Omaha Public Power District
444 South 16th Street Mall
Omaha, NE 68102-2247

LIC-15-0069
May 13, 2015

Fort Calhoun Station, Unit No. 1
Renewed Facility Operating License No. DPR-40
NRC Docket No. 50-285

Subject: Omaha Public Power District (OPPD) Response to NRC Request for
Additional Information Regarding Relief Request RR-14

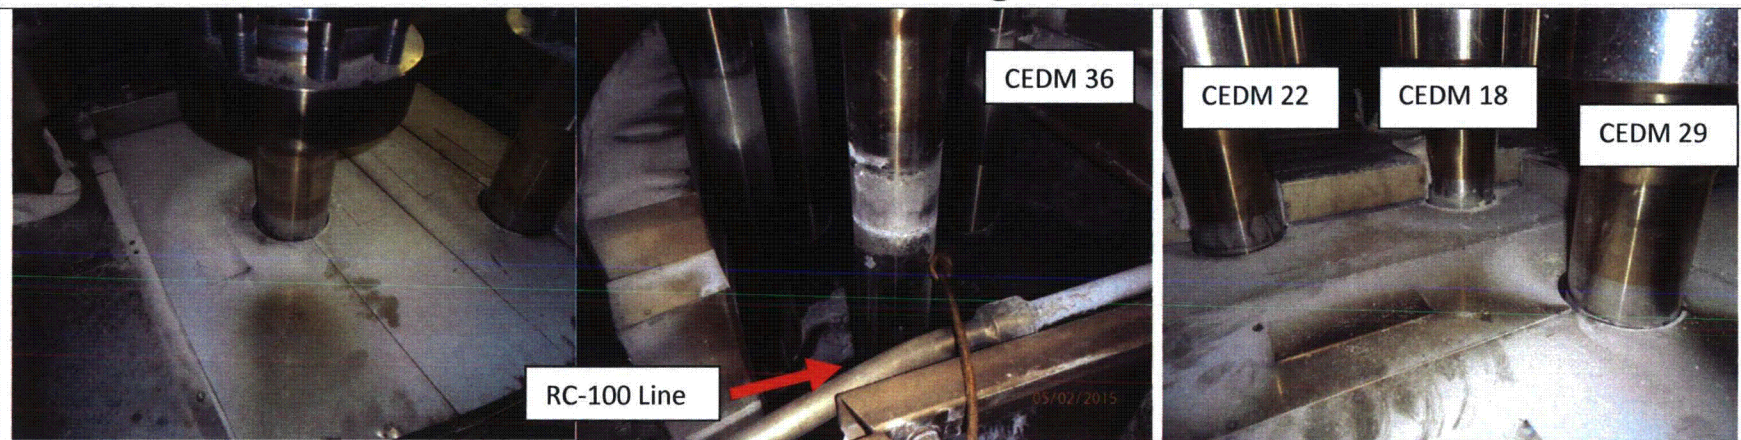
ICI Nozzle 47	As-Found	As-Left
<p>Question 1 (a). Indication of possible light Boric Acid deposits on base of penetration (b). Initial Evaluation as Not Relevant later re-evaluated as Relevant</p> <p>Question 2 (b). See Answer 3 (c). Sample not performed.</p> <p>Question 3 The angle of the slope around penetration 47 is quite steep which would allow deposits from above to easily collect around it. The deposits found were of a very light amount and no deposits near the annulus. This would be expected for the amount of deposits above penetration around Nozzle 37.</p> <p>Question 4 See Answer 3 for basis of not evaluating per -3142.1(b)(1) of CC N-729-1 *Leak Source determined RC-100 packing leak (WO #551054)* *Post Cleaning VE determined acceptable*</p>
